RE: PETITION NO. 1184 - Beacon Falls Energy Park, LLC petition for a declaratory ruling that no Certificate of Environmental Compatibility and Public Need is required for the proposed construction, operation, and maintenance of a 63.3 Megawatt AC fuel cell facility located on Lopus Road, Beacon Falls, Connecticut.

Petition 1184
Beacon Falls Energy Park
Petition Interrogatories

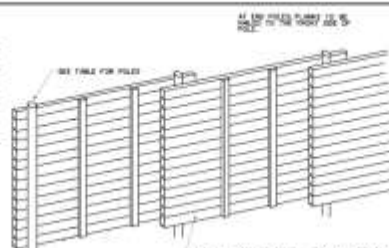
5. Regarding Petition Section 5.4.2, identify the nearest residential property to the fuel cell compound fence.

A5: The approximate distance (per the “6-11-15 C-300-Model” drawing) from the fuel cell compound fence to the nearest residential property, 38 Gruber Road, is 270 feet.

ATTACHMENT:
QUESTION # 14

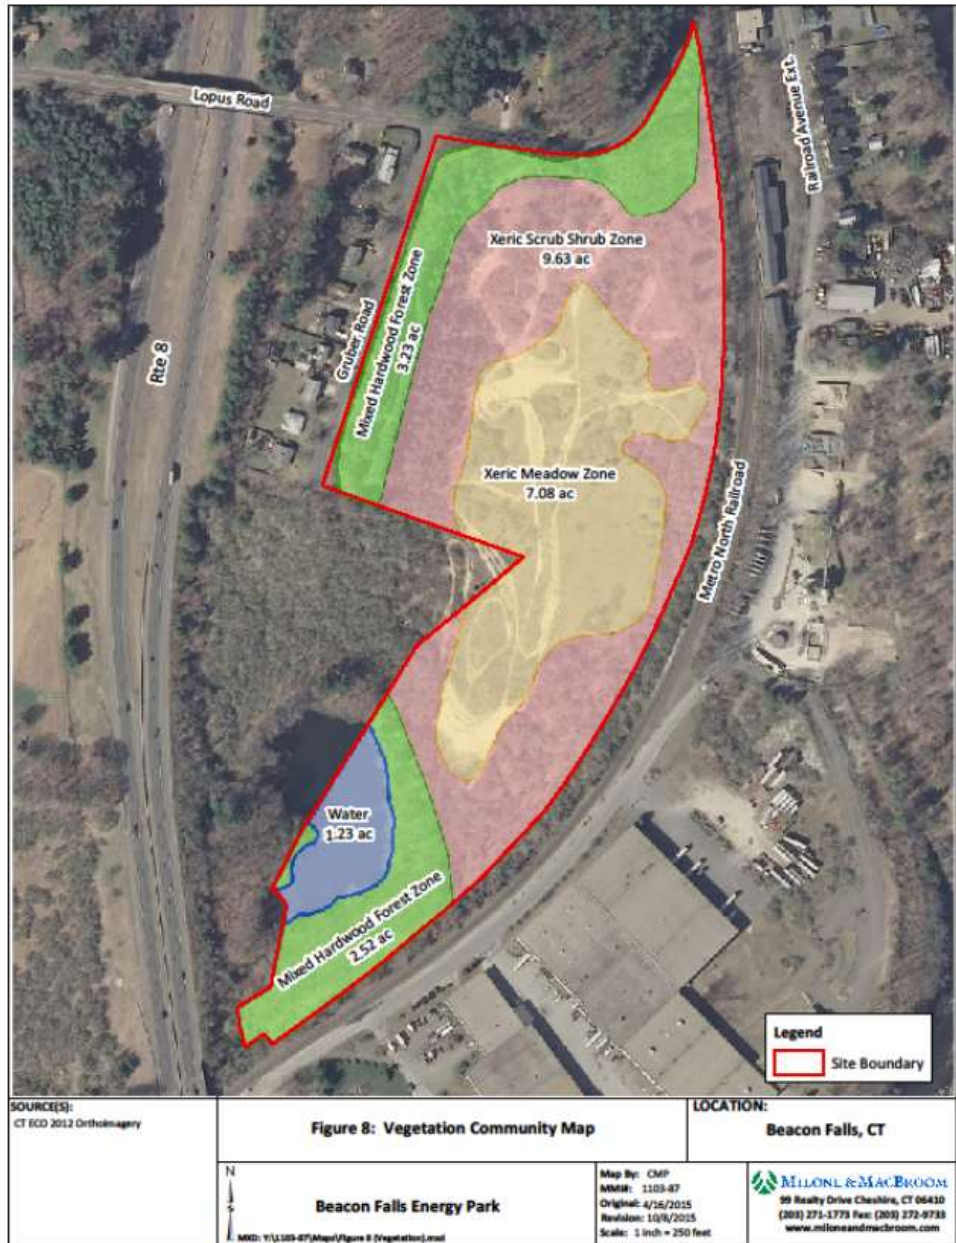
14. Comment on the size of the on-site xeric shrub scrub zone and xeric meadow zone for the potential of these habitats to support a viable populations of hognose snakes and box turtles. Provide literature citations to support conclusions based on habitat fragment size.

A14: Neither of these special concern species was encountered during the many field hours spent on-site. The recommended protocol of pre-construction searches and sweeps will provide an added measure of protection to local populations, should they exist. The relative size of the xeric scrub-shrub habitat and xeric meadow habitat was estimated from current aerials and USDA – NRCS soil survey maps augmented by field observations. See attached graphic (Attachment 14) for a depiction of the following:

- Xeric scrub-shrub: 9.63 acres
- Xeric meadow: 7.08 acres
- Forest: 5.75 acres
- Water: 1.23 acres
